Access Compliance Report

Public Rights-of-Way

Intersection ID: 2941	Main Street: GOLDENFIELD_DR	Cross Street: SUMMER_CREEK_LN	Location: SE
ADA ID: B1FDDE1C6102	Ramp Type: BlendTrans1	Initial Pass/Fail: Fail	Overall Compliance: No
		Severity Score: 10

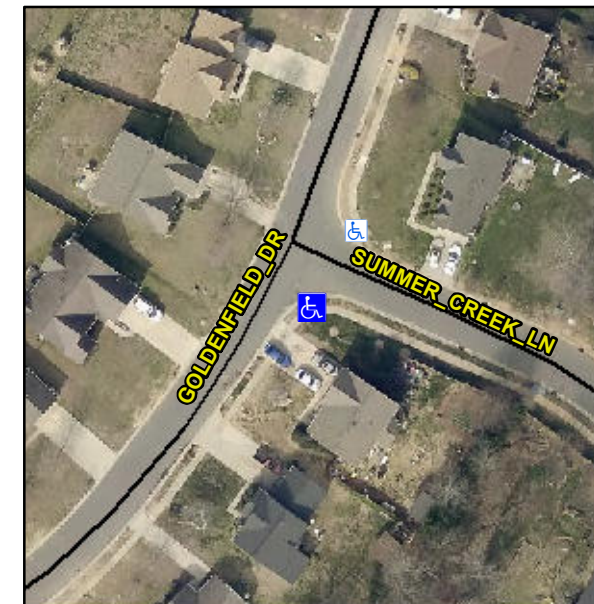
Not Found, R304.5.1, R304.5.3

Compliance	Description	Data	Compliance	Description	Data
N/A	Ramp Length (in)	47.0	Yes	BlendTrans Slope (%)	2.8
No	Ramp Width (in)	44.0	No	BlendTrans XSlope (%)	2.2
N/A	Flare Type LT	N/A	N/A	Flare Type RT	N/A
N/A	Flare Slope LT (%)	N/A	N/A	Flare Slope RT (%)	N/A
N/A	Flare Traversable LT?	N/A	N/A	Flare Traversable RT?	N/A
N/A	Landing Length (in)	N/A	N/A	DWS Provided?	N/A
N/A	Landing Width (in)	N/A	N/A	DWS Contrast?	N/A
N/A	Landing Slope (%)	N/A	N/A	DWS Length (in)	N/A
N/A	Landing X Slope (%)	N/A	N/A	DWS Full Width?	N/A
N/A	Landing Curb? (Y/N)	N/A	N/A	DWS Offset (in)	N/A
N/A	Shared Landing?	N/A			
N/A	Gutter Ponding?	N/A	N/A	Gutter Slope (%)	N/A
N/A	Gutter Lip Ht (in)	N/A	N/A	Gutter X Slope (%)	N/A
N/A	Painted X Walk1?	No	N/A	Painted X Walk2?	N/A
	X Walk 1 Direction	To NE		X Walk 2 Direction	N/A
	X Walk 1 Width (in)	N/A		X Walk 2 Width (in)	N/A
	X Walk 1 Slope (%)	3.6		X Walk 2 Slope (%)	N/A
	X Walk 1 X Slope (%)	0.0		X Walk 2 X Slope (%)	N/A

N/A	Ramp inside XWalk1?	N/A	N/A	Ramp inside XWalk2?	N/A
	Road Slope (%)	0.0		Clear Space?	N/A
	Road X Slope (%)	3.6	N/A	Clear Space to XWalk (in)	N/A
N/A	Any Obstructions?	N/A	N/A	Storm Grate/Utility Hazard?	N/A
	Obstruction Type			Storm Grate/Utility Type	
		N/A			N/A
			Yes	Surface Condition? (G/P)	Good
			No	Curb Slope (%)	17.8

Remove & Replace Curb Ramp With Two New Directional Ramps or Equivalent.
